In response to the Office action mailed November 1, 2004, Applicant respectfully requests reconsideration, reexamination and allowance of claims 1-2 and 5-10 in view of the above amendments and the following remarks.

Amendments to the Figures:

Amendments to the figures are shown on the appended sheet 4 of 21 (FIGS. 4 and 5) and sheet 16 of 21 (FIG. 23). In FIGS. 4 and 5, reference numeral 59 has been added and in FIG. 23 reference numeral 114 has been added. These sheets are annotated as replacements sheets.

Fig. 4

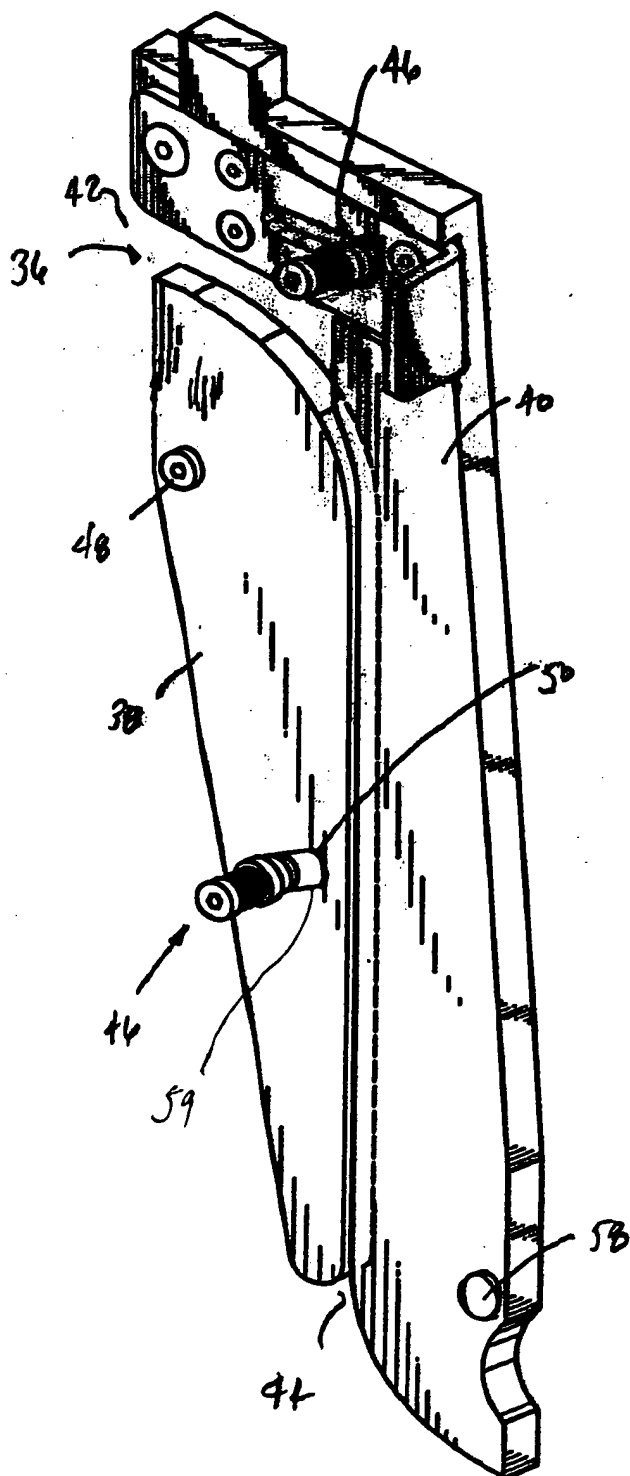
The Examiner has also objected to the use of reference character 58 to indicate both the enlarged portion and the pivot pin. Applicant has, as noted above, amended the specification to change enlarged portion to reference number 59 and has amended FIGS. 4 and 5 accordingly. Applicant respectfully submits that this objection has now been fully addressed and that it be withdrawn.
